Title - Sujet BIO Secondary Access Road Construct	
Solicitation No. - N° de l'invitation EB144-180972/A	Amendment No. - N° modif. 003
Client Reference No. - N° de référence du client EB144-18-0972	Date 2017-09-19
GETS Reference No. - N° de référence de SEAG PW-\$PWA-122-5643	
File No. - N° de dossier PWA-7-78059 (122)	CCC No./N° CCC - FMS No./N° VME
Solicitation Closes - L'invitation prend fin at - à 02:00 PM on - le 2017-09-26	Time Zone Fuseau horaire Atlantic Daylight Saving Time ADT
F.O.B. - F.A.B. Plant-Usine: <input type="checkbox"/> Destination: <input checked="" type="checkbox"/> Other-Autre: <input type="checkbox"/>	
Address Enquiries to: - Adresser toutes questions à: Chinye (PWA), Chukwudi	Buyer Id - Id de l'acheteur pwa122
Telephone No. - N° de téléphone (902) 496-5476 ()	FAX No. - N° de FAX (902) 496-5016
Destination - of Goods, Services, and Construction: Destination - des biens, services et construction:

Amendment 003 is raised to incorporate the following changes to Appendix 1-Combined price form, and respond to questions posed. This amendment is also raised to incorporate changes to the specification and drawings.

ASPHALT STRUCTURE PARKING LOT

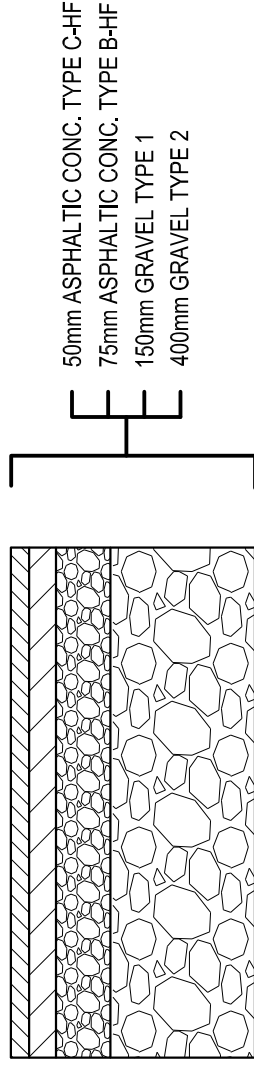
Question 10: Provide details on the asphalt and gravel structure for the parking expansion as shown on DWG C21. How will we be getting paid for this work?

- .1 ADD 'Detail 11 – Asphalt Structure Parking Lot' on CSK-08 (attached).

Answer to Question 10: Pavement structure detail provided. Quantities will be paid under existing gravel and asphalt paving unit price items. Refer to Addendum revision to Drawing C23 for detail, as well as Specification Section 01 29 00 – Measurement and Payment.
